AMENDMENTS TO THE DRAWINGS

REMARKS

FIG. 14

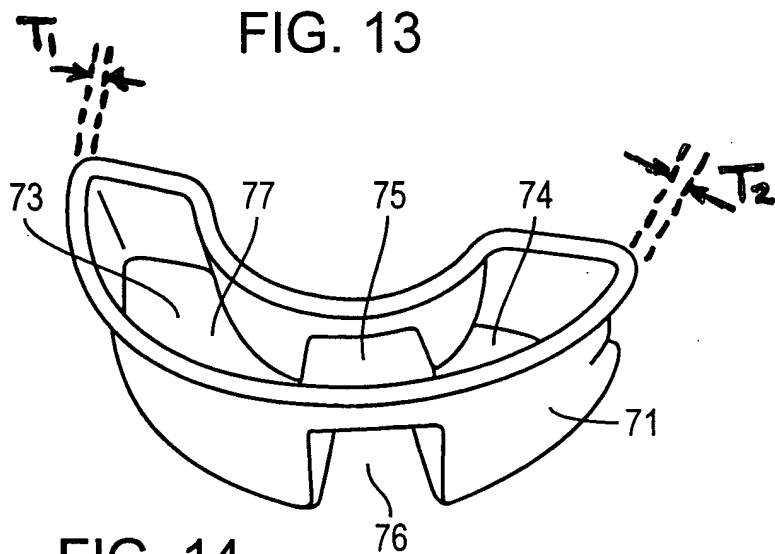
The drawings are amended to overcome the objection under 37 CFR 1.83(a) as not showing every feature of the invention specified in the claims. Please replace sheet 11 of the drawings depicting FIGS. 13-15B with the enclosed proposed sheet 11 of the drawings including amended FIG. 14.

1. The drawings are objected to under 37 CFR 1.83(a) as not showing every feature of the invention specified in the claims. Applicants have amended FIG. 14 as shown in the attached Replacement Sheet to clearly indicate the varying wall thickness, as recited in claim 28. Paragraph [0055] of the specification, as filed, has been amended to be consistent with amended FIG. 14.
